## **Subject: Meritor WABCO OnGuard System**

**Models Affected: Specific Freightliner Cascadia vehicles manufactured November 13, 2012, through March 13, 2014, with a Meritor WABCO OnGuard system.**

Daimler Trucks North America LLC, on behalf of its Freightliner Trucks Division, is initiating Field Service Campaign SF499A-H to modify the vehicles mentioned above.

September 2014  
SF499A-H  
REVISED NOTICE

**Fig. 9, OnGuard Harness Routed Under the Forward Crossmember**

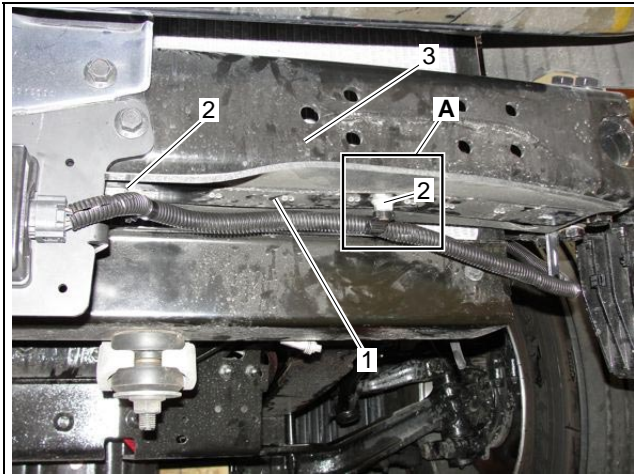
1. Remove the bumper.
2. Locate the radiator air baffle on the driver's side of the vehicle, and remove the two mounting bolts nearest to the OnGuard mounting bracket. See **Fig. 9**. Flip the orientation of the bolts and install them so that the threads are facing down. Tighten the nuts securely.
3. Position a stud-mount tie strap (23-12115-001) on each bolt thread, then secure the harness. See **Fig. 9**.
4. Install the L-bracket.
  - 4.1 Remove the center mounting bolt from the driver's-side frame rail extension. See **Fig. 10**.
  - 4.2 Position the L-bracket (23-09130-007) on the frame rail extension at a 45° angle so that the "L" is facing away from the vehicle, then install the bolt.
  - 4.3 Tighten the nut to 135 lbf-ft (184 N-m).

**Fig. 10, Harness Secured to the L-Bracket**

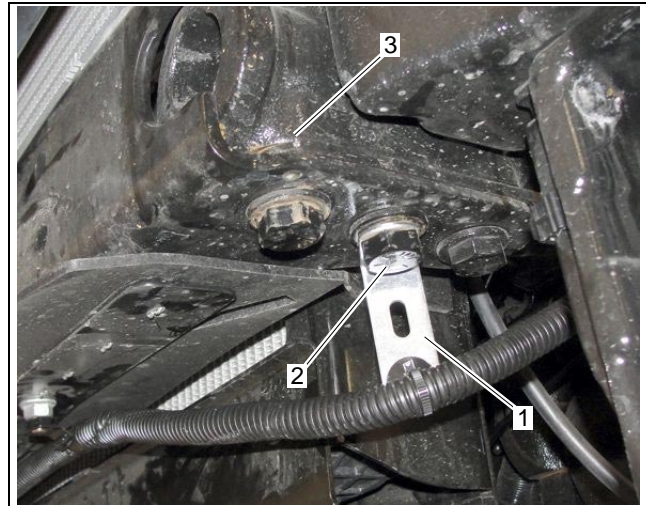
**IMPORTANT:** Make sure that the harness is oriented away from the OnGuard mounting bracket. The harness will be chafed and damaged if it contacts the bracket.

4.4 Secure the harness to the L-bracket with a push-on tie strap (23-13481-000). See **Fig. 10**.
